SUBJECT: Acceptance of the Final Environmental Impact Statement for the Diamond Head  
State Monument Master Plan Update

*Diamond Head State Monument  
Master Plan Update*

**Final Environmental Impact Statement**

Prepared by:  
PBR HAWAII

**FIGURE 2**  
**Tax Map Key 3-1-42**  
**DIAMOND HEAD STATE MONUMENT**

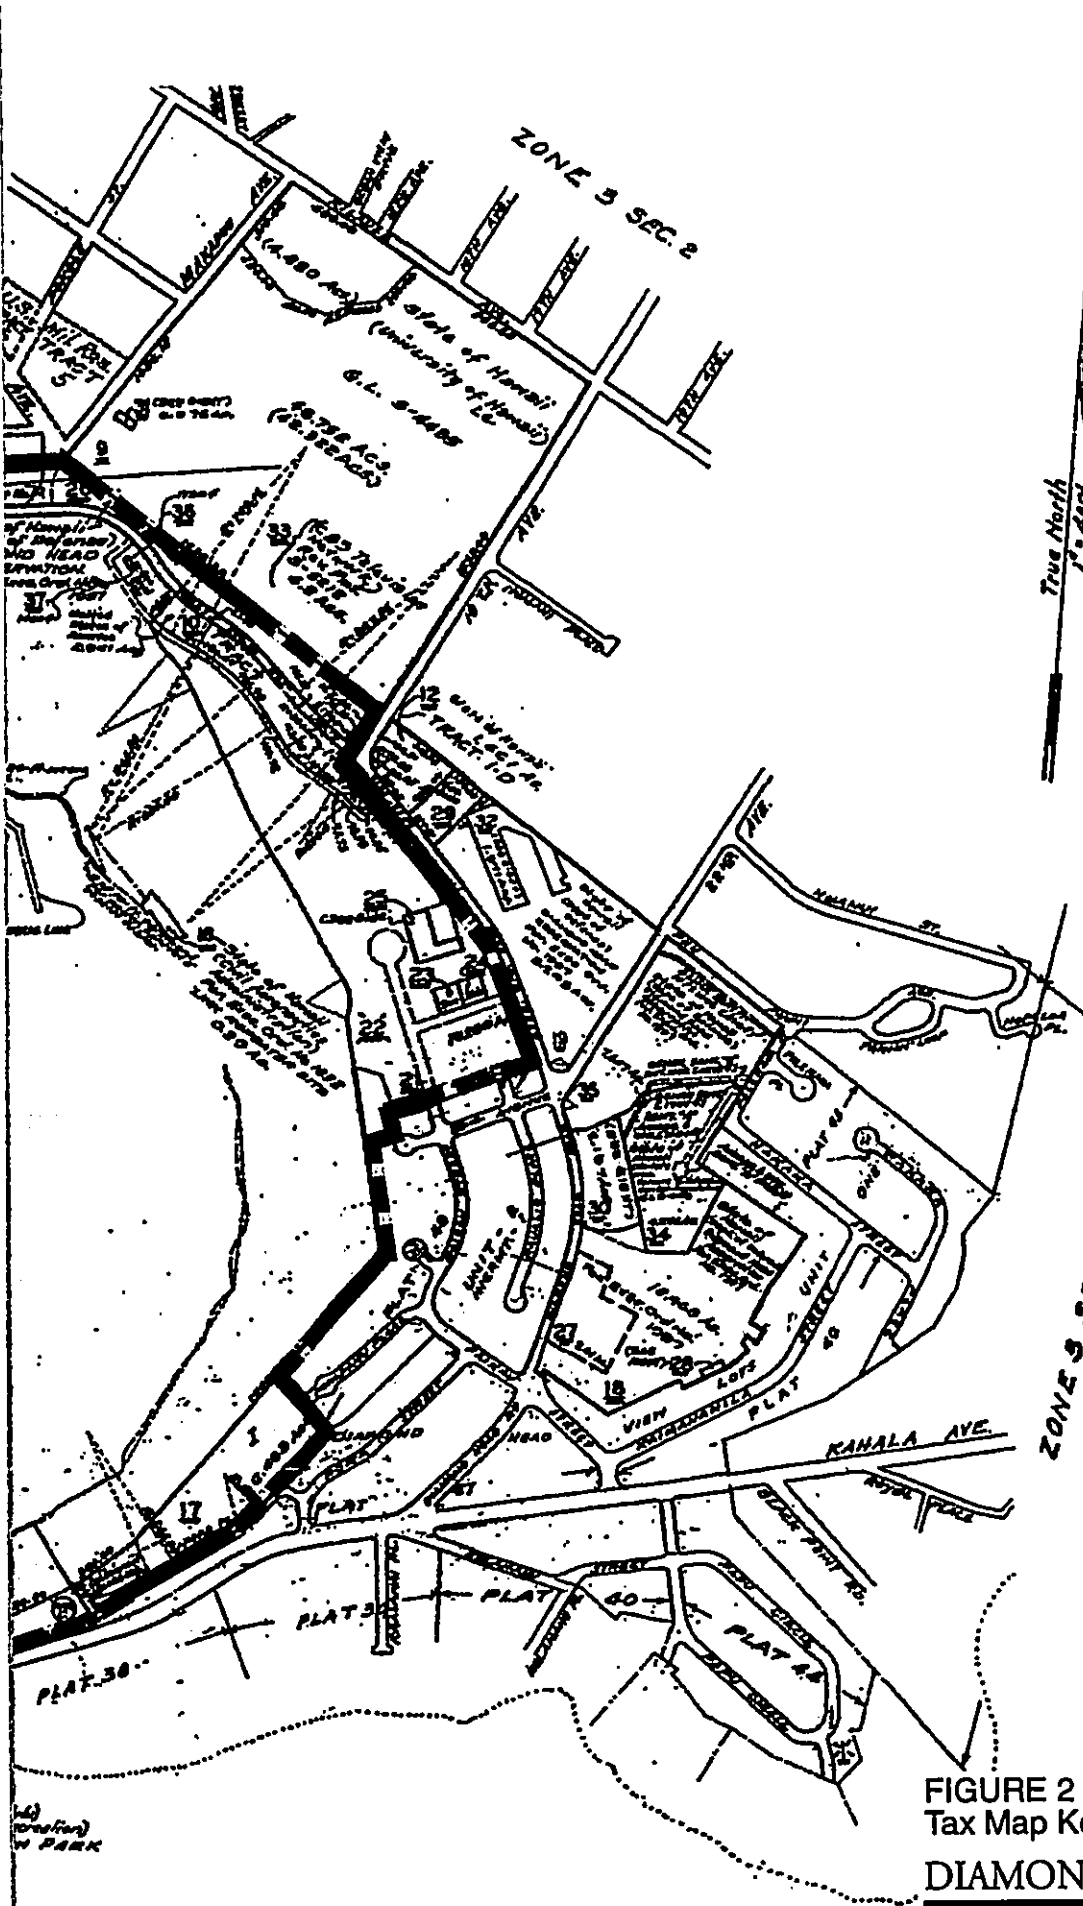
Please note that Figure 2, Tax Map Key 3-1-42 is illegible. In the final document, please ensure that all figures are clear. Confirm that this figure will be redrawn.

Figure 2 will be enlarged to 11" by 17" so that it is more legible.

**FIGURE 3**  
**State Land Use District Boundary Map**  
**DIAMOND HEAD STATE MONUMENT**

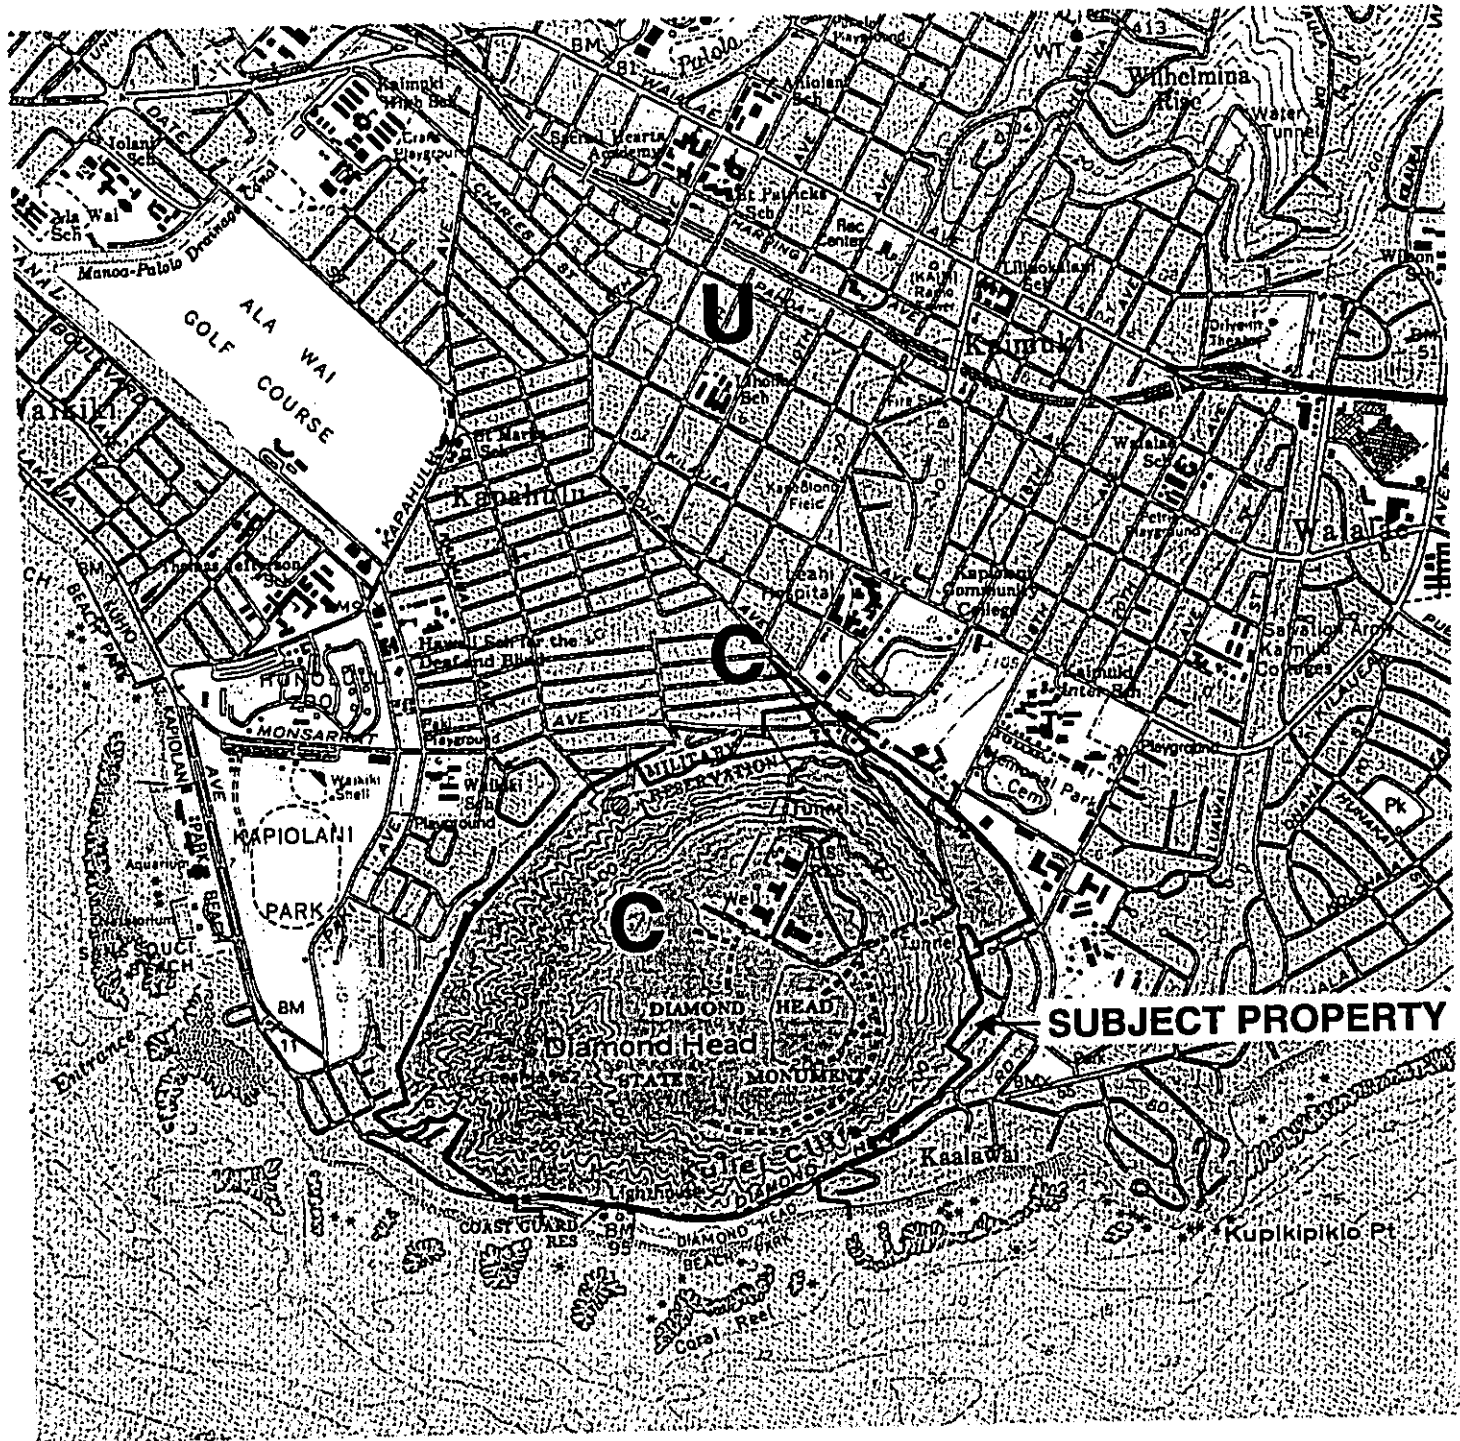
Based on our review of Figure 3, it is not clear whether the reclassified area has been designated within a subzone. Clarification should be provided on this matter.
